CITY OF ALBUQUERQUE

Planning Department
Alan Varela, Director

**RE: Paseo and Kimmick East
99999 Valiente Rd NW
Conceptual Grading & Drainage Plan
Engineer's Stamp Date: 08/26/2025
Hydrology File: C11D010
Case # HYDR-2025-00311**

PASEO AND KIMMICK EAST
ALBUQUERQUE, NM
CONCEPTUAL GRADING
AND DRAINAGE PLAN

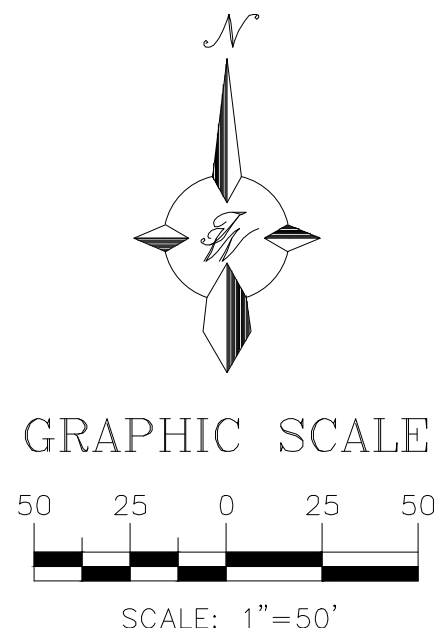
Based upon the information provided in your submittal received 08/27/2025, the Conceptual Grading & Drainage Plan is preliminary approved for action by the Development Facilitation Team (DFT) / Development Hearing Officer (DHO) on Site Plan for Building Permit and platting action.

1. Please submit a more detailed Grading & Drainage Plan to Hydrology for review and approval.
